1 **Comment (#85, #100, #101, #125, #127, #132, #133, #134, #136, #137)**

3 Single signature state machines

1 Suggested Remedy:

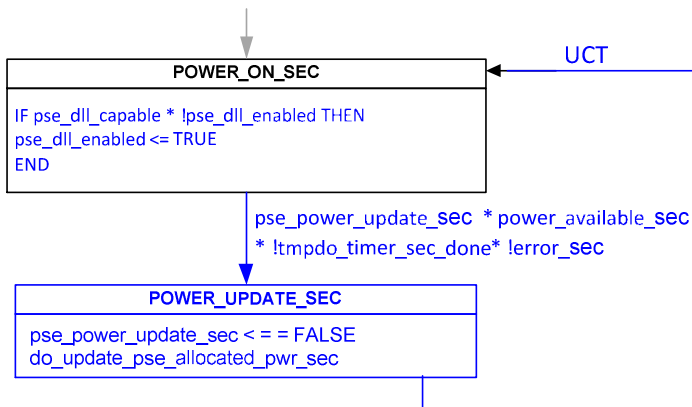
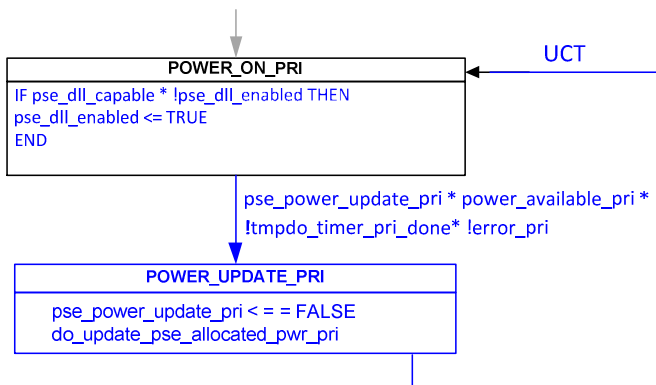
23 **1. Delete DLL_ENABLE states and the in/out arrows to I and Change Figure 145-15**
24 **and Figure 145-16 as follows:**

Figure 145-26—Type 3 and Type 4 single-signature PD state diagram

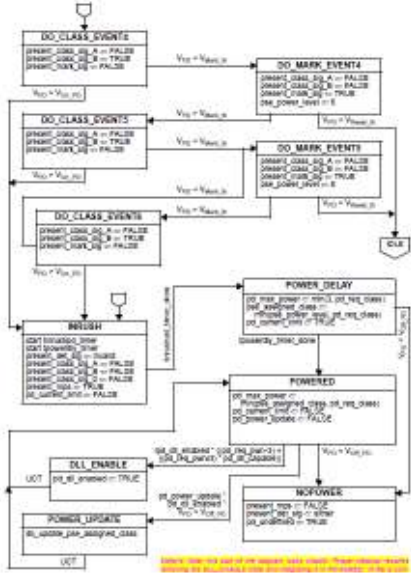
-Editor to replace pd_req_pwr variable (it is PSE and not PD variable) with pd_req_class in Figure 145-27 in all locations.

-Editor to remove “BEGIN” from the relevant states per yseboodt_07_0317.pdf proposal

- 1 **Figure 145–29—Type 3 and Type 4 dual-signature PD state diagram**
- 2 *-Change the suffix `_mode(M)` to `_mode(X)`.*
- 3 *-Make the following changes in Figure 145-30.*
- 4

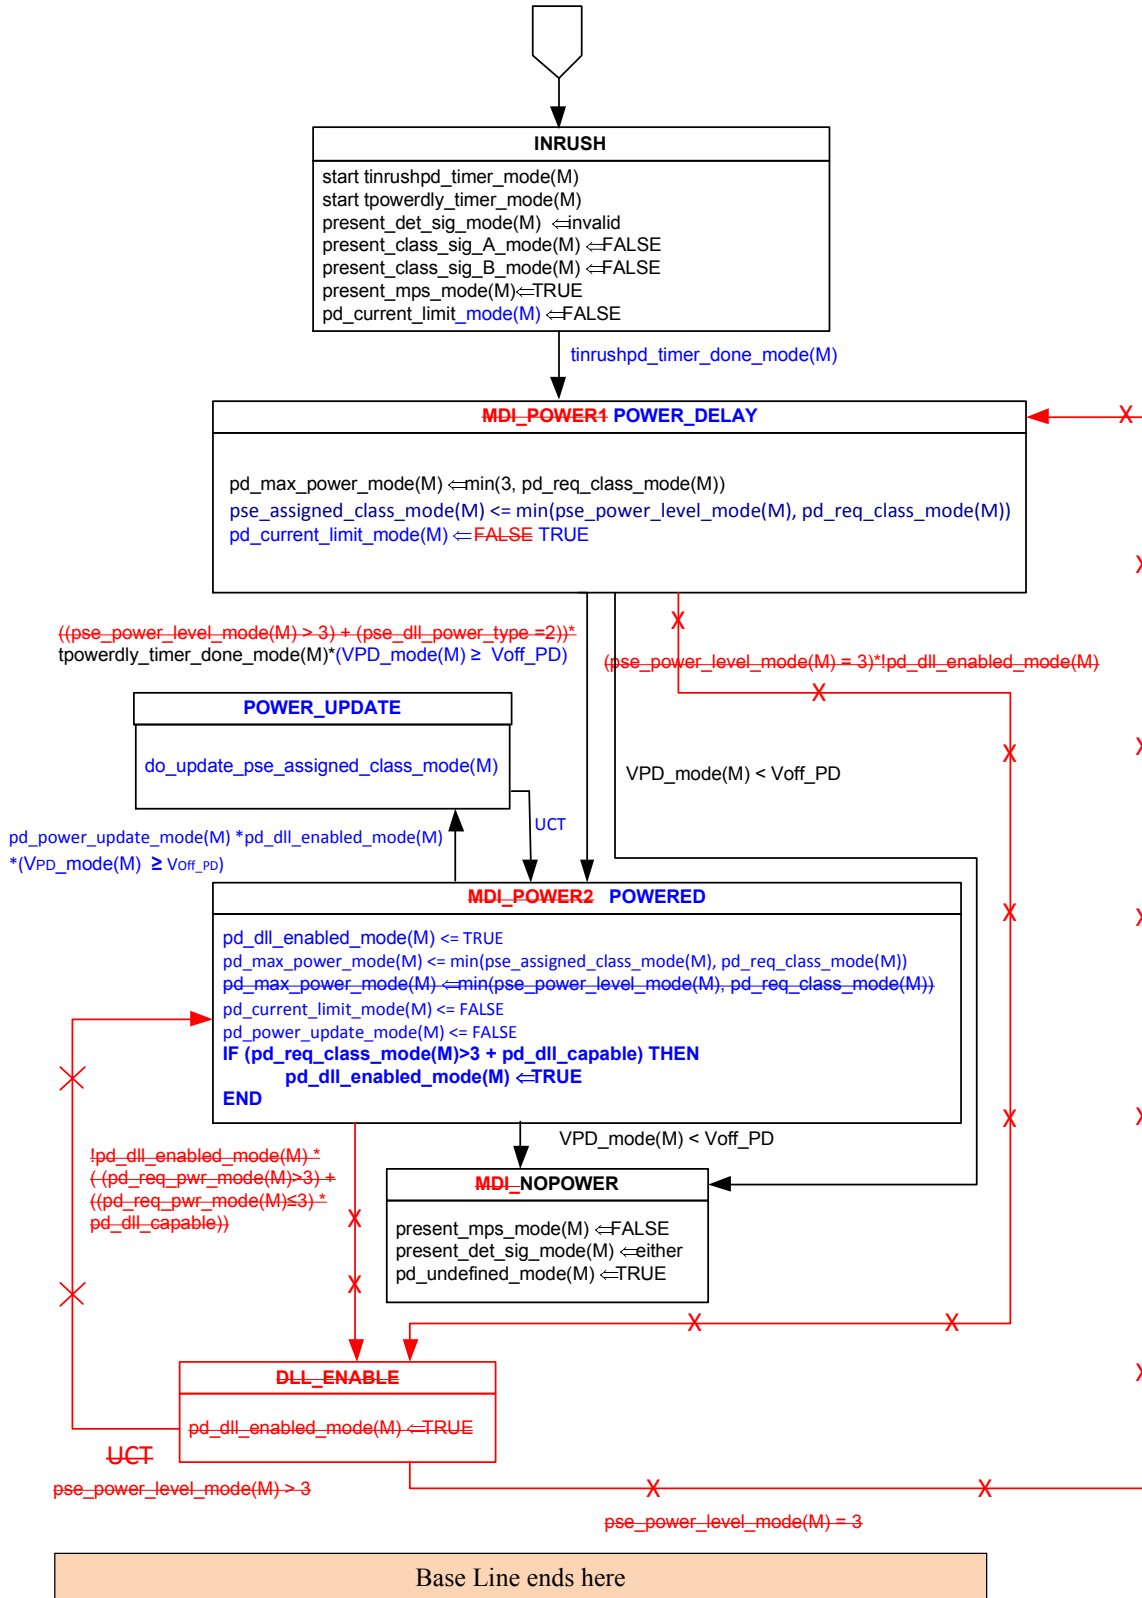
- 1 **145.3.3.12 Dual-signature PD state diagrams**
- 2 *-Change the suffix `_mode(M)` to `_mode(X)`.*
- 3 *-Change from `VPD_mode` to `VPD_mode` in all occurrences.*
- 4 *-Remove “BEGIN” from the relevant states per yseboodt_07_0317.pdf proposal*
- 5 *-Make the following changes in Figure 145-29.*
